Meeting Date:
March 9, 2026

Request:
Conditional Use and Site Plan request for Western Reserve Academy for an addition to the Wang Innovation Center.

Staff Recommendation
Continue subject to recommendations on page 10.

Hudson Planning Commission	CONDITIONAL USE/SITE PLAN REVIEW – WRA – WANG INNOVATION CENTER
Case No. 2026-72	March 9, 2026

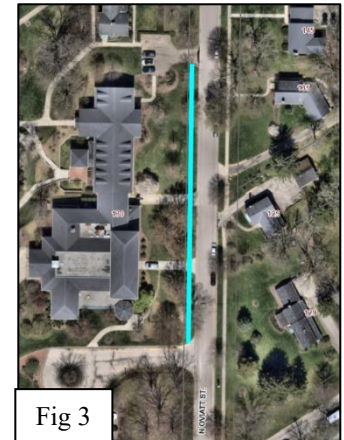
Staff Comment: Staff recommends sidewalks be installed along N Oviatt between the adjacent curb cuts to meet this requirement (see Figure 3).

1. Revise the civil drawings to incorporate stormwater improvements to the northern pond in order to be compliant with the requirements for retention/detention as stipulated in Section 1207.07.
2. Revise the civil drawings to include a sidewalk extension as depicted in Figure 3 of the staff report in order to be compliant with pedestrian pathways and linkages requirements of Section 1205.04(d)(11).
3. Further study tree and vegetation protection per the analysis on pages 7 and 8.

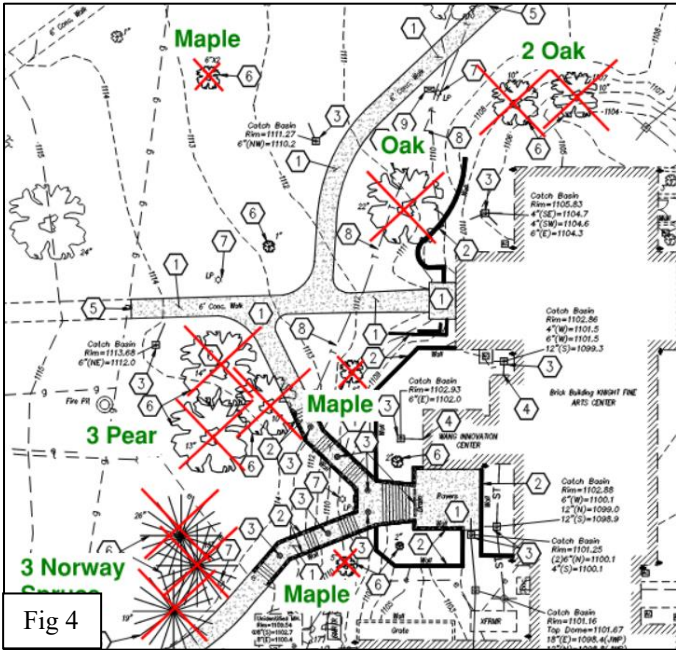
Staff notes several mature trees are proposed to be removed in order to accommodate the improvements (see Figure 4). Staff has reviewed the proposal with the City Arborist with the following comments:

- The Land Development Code states “*Whenever practicable, significant trees and existing vegetation within the limits of disturbance should be preserved*”. Question if the site plan could be modified to retain the three mature Norway Spruce trees (See Figure 5).

- The two trees marked for removal on the north side of the building are maples, not oaks as indicated.
- The size and species of the proposed plant material is acceptable.

- Out of the trees proposed to be preserved, the Catalpa located the southwest corner of the proposed addition is most susceptible for construction damage. The City Arborist recommends root pruning prior to construction where the roots are likely to be severed. If root pruning doesn’t occur prior to bud break, state that roots should be cut cleanly with a saw, not torn with excavator bucket. Cut roots should be backfilled promptly to prevent desiccation

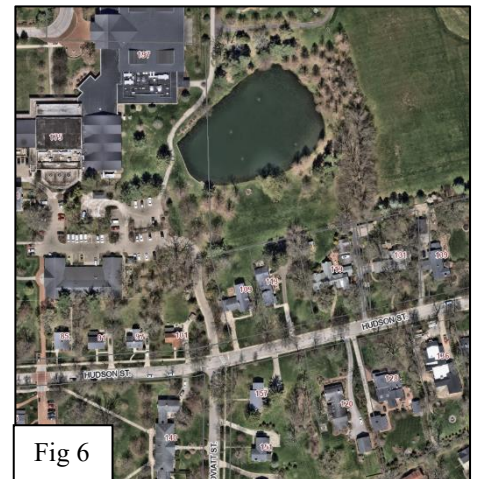
The Assistant City Engineer has reviewed and suggested modifying the pond to the north (see Figure 6) to fulfill the LDC requirement of stormwater retention/detention for new major development proposals. The Assistant City Engineer recommends the pond be enlarged and the control structure be modified to reduce storm flow. This pond is located in the same drainage basin as the proposed building addition and would provide benefit for heavier storms.

Staff recommends the applicant design these modifications and submit for review as part of this application.
